# Glenmore Trail East Study

What We Heard  
Report

November 2016

#### Short-term improvements at 100 Street S.E.

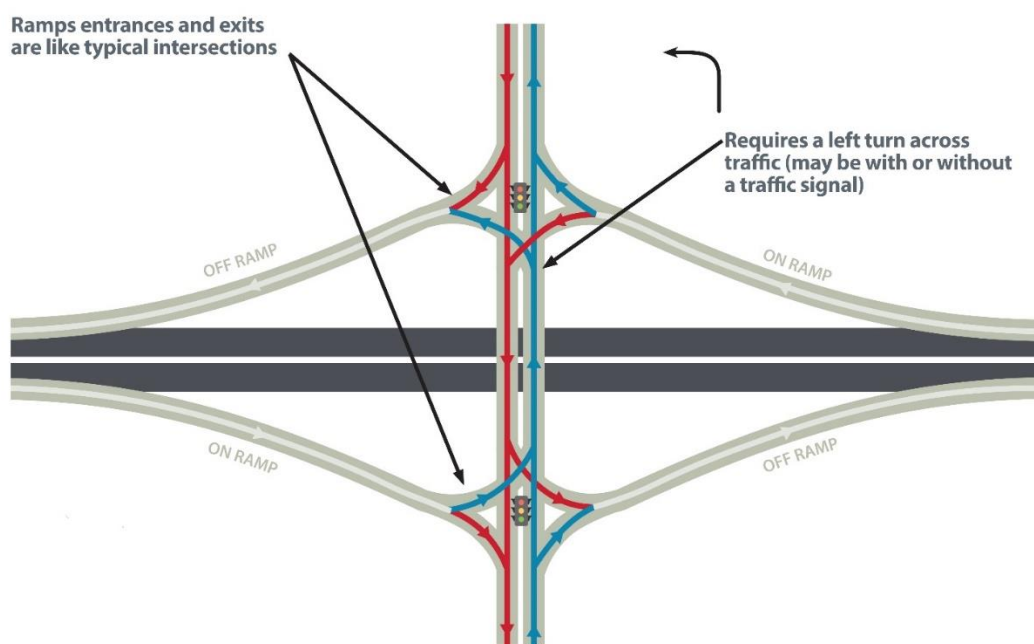
- No (13)
- Road needs to be widened – concerns about going back to one lane over bridge (7)
- Timing – needs to be completed sooner than later (5)
- Signal optimization (3)
- Waste of money (3)

- In favour of additional lanes (11)
- Concern about going back to single lane after intersection (5)
- Light synchronization needed (3)

### **Option 1 – Conventional Diamond Interchange**

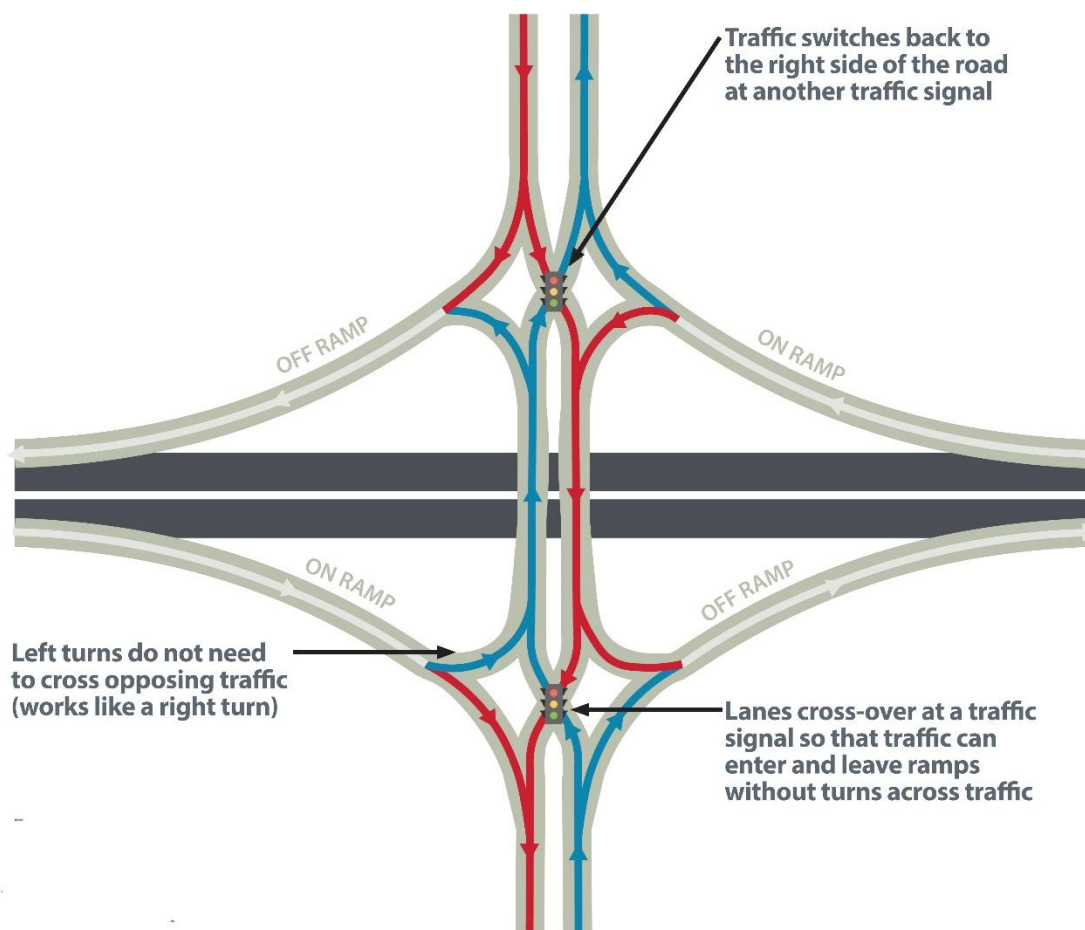
- No (4)
- Doesn't solve big truck issue (4)
- Works well (3)
- Don't like Diamond interchanges (3)
- Don't like left turns / signals (3)
- Cloverleaf would be better (3)

- Make it a cloverleaf (5)
- No (4)

## Option 2 – Diverging Diamond Interchange

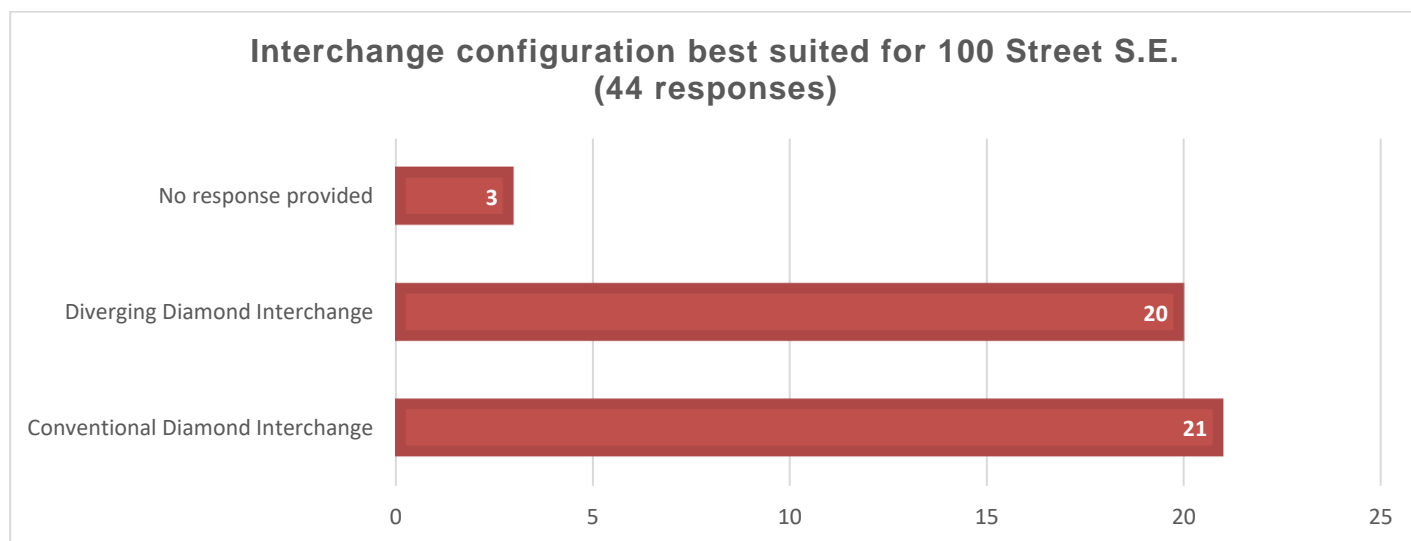
- Too confusing (8)
- It is a better / preferred option (5)
- Doesn't work for large trucks (3)
- Don't need interchanges at both 100 Street S.E. and 116 Street S.E. (2)
- Cloverleaf would be better (2)
- No (2)

- No (5)
- Don't do this plan (3)
- Bigger interchange at 100 Street S.E. and smaller interchange at 116 Street S.E. (2)
- Cloverleaf (2)
